Key Points for Planning Commission -

Thank you for taking the time to consider our input on the development proposed for 16220 Harwood road.

Doug and Pam McCracken 16224 Harwood Road 8/11/23

16224 Harwood Rd

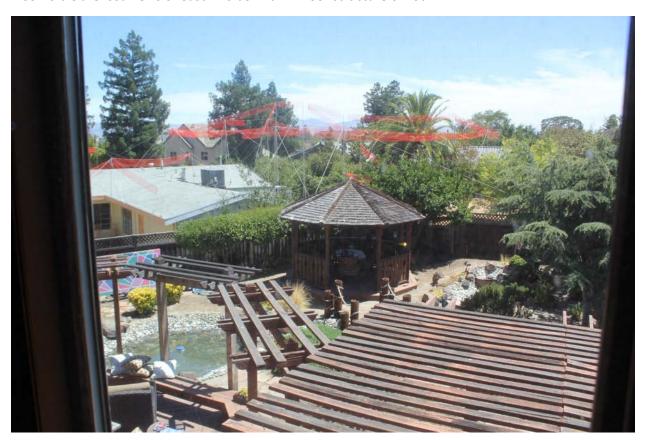
View from 2nd floor kids bedroom, looking at Lot B front yard and front of proposed structure. Lot B home has large window at stairs as well as 2nd floor windows with unobstructed views of all rooms on our 2nd floor. Quite literally Lot B is a home dropped in directly behind ours.

16224 Harwood road – privacy issues with backyard, patio, spa.

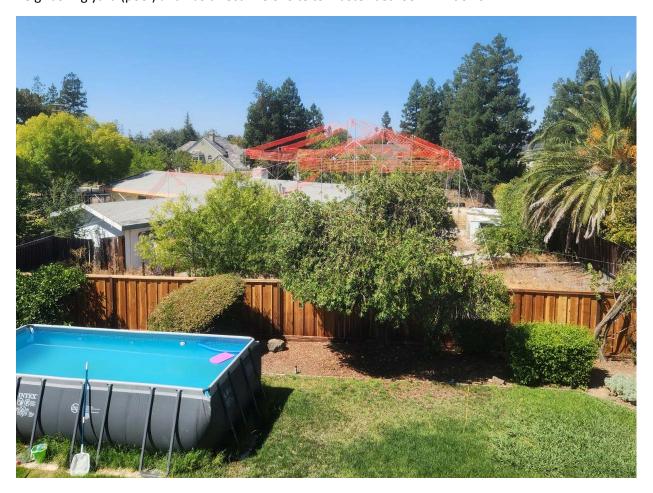
Backyard patio/spa loses all privacy to Lot B. Lot C balcony has line of site view to full backyard and 2nd story windows of our house. Every time the Lot B residents arrive or leave their home they will have a great view of our backyard and windows.

- I recommend any impact to the fence and/or retaining wall on our shared property be required to be replaced with the maximum permitted height of 8 foot (full board, no lattice).
